SUBJECT : ImageQuest Co., Ltd.
FCC ID: PJIET1925L
FCC Part 15 Subpart B Certification
(Class II Permissive Change)

Transmitted herewith, on behalf of ImageQuest Co., Ltd. is an application for a FCC Part 15 Subpart B Certification of the following 19-inch LCD Kiosk Touch Screen Monitor (Serial Interface Type) :

FCC ID : PJIET1925L
Model No. : ET1925L-7SWA-1

1. Apply a ferrite core to the OSD signal interface cable

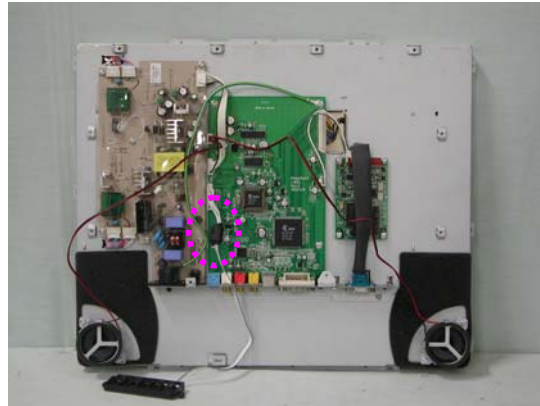
1. Apply a ferrite core to the OSD signal interface cable
2. Attach a gasket on the main board
3. Attach a gasket on the LCD panel
